## 304.3.1 Circular Turning Space

**CHANGE TYPE:** Modification

**CHANGE SUMMARY:** Within new buildings, the size of a circular turning space has been increased from the previous 60-inch requirement up to 67 inches. The amount of knee and toe space beneath an obstruction that can be included in the turning space clearance has become more limited.

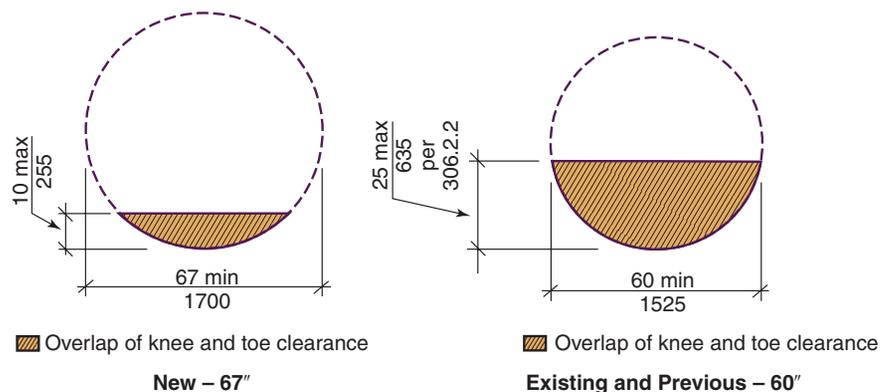
**304.3.1.1 New buildings and facilities.** In new buildings and facilities, the turning space shall be a circular space with a 67 inch (1700 mm) minimum diameter.

**304.3.1.1.1 Overlap.** Turning spaces shall be permitted to include knee and toe clearance complying with Section 306. Where the turning space includes knee and toe clearances under an obstruction, the overlap shall comply with all of the following:

1. The depth of the overlap shall not be more than 10 inches (255 mm), and
2. The depth shall not exceed the depth of the knee and toe clearances provided, and
3. The overlap shall be permitted only within the turning circle area shown shaded in Figure 304.3.1.

**CHANGE SIGNIFICANCE:** This change is a part of the work of the Wheeled Mobility Task Group. This task group of the A117.1 committee analyzed the results of the anthropometric study conducted by The Center for Inclusive Design and Environmental Access (IDeA) at the University at Buffalo, SUNY, evaluating a variety of mobility device users. This study queried around 500 manual and powered wheeled mobility

The requirements for new buildings also include a limitation on the amount of the turning space that may be overlapped by fixtures or elements that have knee and toe clearances beneath them. Previously the standard did not place a limit on the amount of the space that could be located beneath a fixture or element. Other than a 36-inch-wide accessible route into and out of the space, the turning space could potentially have had obstructions on two or three sides, and these obstructions could in total have extended to close to the 25-inch maximum depth allowed for knee and toe clearances. With the new provisions, the overlap is limited to being on only one side and is limited to a maximum overlap depth of 10 inches if knee and toe clearance is provided beneath the fixture.

**2017 STANDARD: 304.3.2 T-shaped space.**

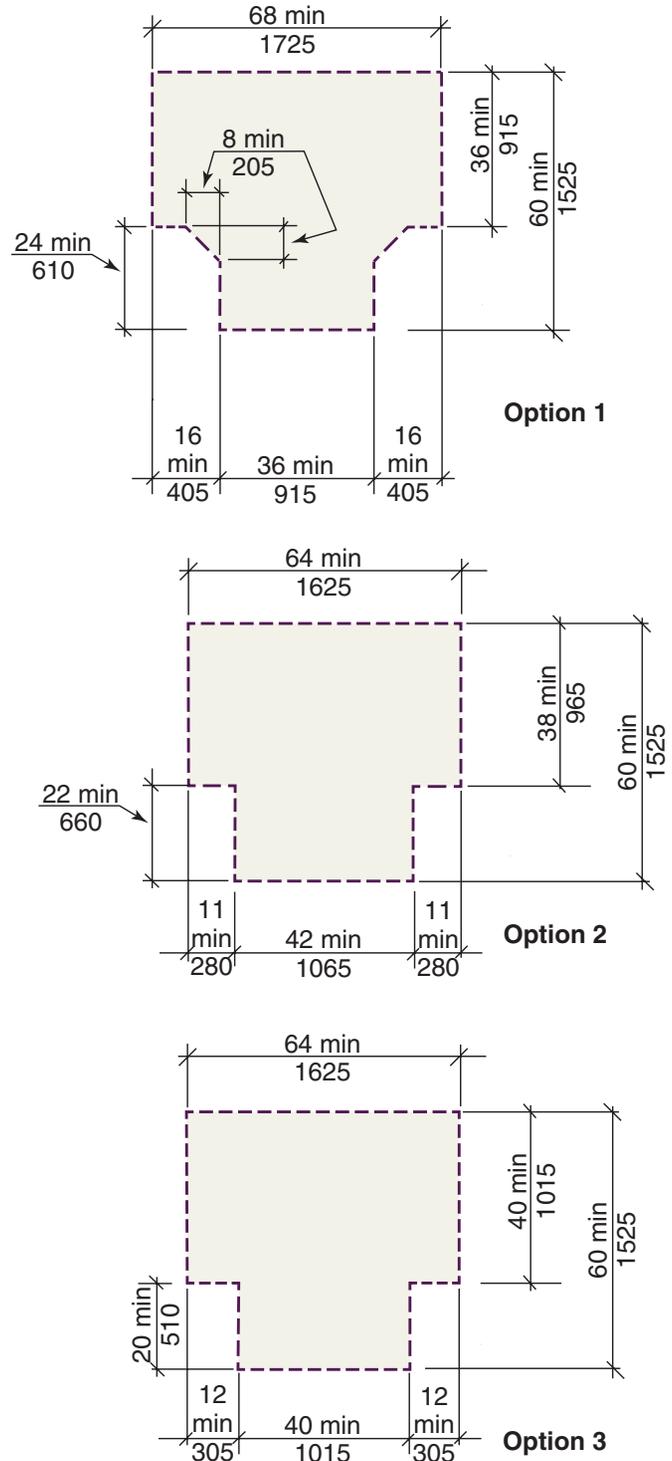
**CHANGE SUMMARY:** Three options are allowed for T-shaped turning spaces in new construction and vary depending on the width of the arms on the T-shaped space. All of the options result in an increased size for the turning space, while existing buildings can continue to use the previous criteria.

**304.3.2.1 New buildings and facilities.** In new buildings and facilities, the turning space shall be a T-shaped space complying with one of the following:

1. A T-shaped space, clear of obstruction, that fits within an area 68 inches (1725 mm) wide and 60 inches (1525 mm) deep, with two arms and one base that are all 36 inches (915 mm) minimum in width. Each arm shall extend 16 inches (405 mm) minimum from each side of the base located opposite the other, and the base shall extend 24 inches (610 mm) minimum from the arms. At the intersection of each arm and the base, the interior corners shall be chamfered for 8 inches (205 mm) minimum along both the arm and along the base.

2. A T-shaped space, clear of obstruction, that fits within an area 64 inches (1625 mm) wide and 60 inches (1525 mm) deep, with two arms 38 inches (965 mm) minimum in width and a base 42 inches (1065 mm) minimum in width. Each arm shall extend 11 inches (280 mm) minimum from each side of the base, located opposite the other, and the base shall extend 22 inches (560 mm) minimum from each arm.

3. A T-shaped space, clear of obstruction, 64 inches (1625 mm) wide and 60 inches (1525 mm) deep, with two arms and one base 40 inches (1015 mm) minimum in width. Each arm shall extend 12 inches (305 mm) minimum from each side of the base and the base shall extend 20 inches (510 mm) minimum from each arm.

**CHANGE SIGNIFICANCE:** In order to accommodate the larger wheeled mobility devices, scooters and wheelchairs, the T-shaped turning space requirements have been modified. Primarily the change is seen in Section 304.3.2.1, which will provide three options for the layout of the T-shaped space. These three options will vary depending on the overall size of the space as well as the width of the arms and leg of the T. The three options will range from a 68-inch by 60-inch space with arms and a base that are 36 inches in width and having chamfered corners, to a 64-inch by 60-inch option that relies on both of the arms and the base being increased to a 40-inch width to ease maneuvering.

Where previously the standard included the design criteria for only one size (a 60-inch by 60-inch space with 36-inch wide arms and base), the new standard allows the designer to use any of the three options depending on her or his preference and the layout of the design. The standard does not establish any preference or ranking for the three options, and any of the three would be considered acceptable and provide an adequate T-shaped turning space.

The top graphic is for New Buildings and the bottom graphic is for Existing Buildings.

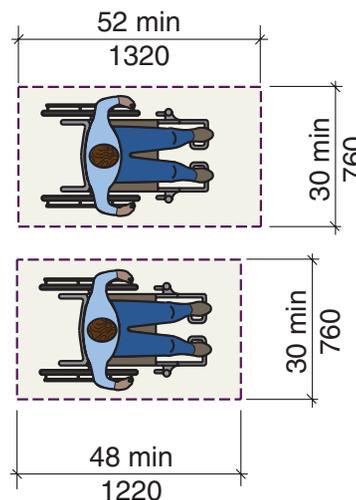
**CHANGE SUMMARY:** This change increases the length of a clear floor space from 48 inches to 52 inches in order to accommodate more wheeled mobility devices and ensure access is provided at various elements. The increased length is required for new buildings while existing buildings may continue to use the previously allowed 48 inch length.

**305.3.1 New buildings and facilities.** In new buildings and facilities, the clear floor space shall be 52 inches (1320 mm) minimum in length and 30 inches (760 mm) minimum in width.

**305.3.2 Existing buildings and facilities.** In existing buildings and facilities, the clear floor space shall be 48 inches (1220 mm) minimum in length and 30 inches (760 mm) minimum in width.

**CHANGE SIGNIFICANCE:** The standard has modified the size of the clear floor space provisions to help accommodate many of the larger wheeled mobility devices that are currently in use. As discussed with several of the previous changes, the application of the increased sizes has been limited to new buildings and facilities, and the previously existing provisions have been designated and considered acceptable for “existing buildings.”

While the change in length from 48 inches to 52 inches in this one section may not seem significant, because this clear floor space is a “building block” requirement from Chapter 3 of the standard and is used for items throughout the standard, the impact is much larger. Based on the research

submitted to the A117.1 committee, the existing 48-inch length for the clear floor space will be inadequate for 22 percent of occupied wheeled mobility devices (WMDs) and for about 12 percent of unoccupied WMDs. This need for increased length is typically associated with the use of scooters, power wheelchairs or wheelchairs that recline. According to the information submitted to the committee, increasing the clear floor space length to 52 inches will accommodate more than 95 percent of the unoccupied and 89 percent of the occupied WMDs.
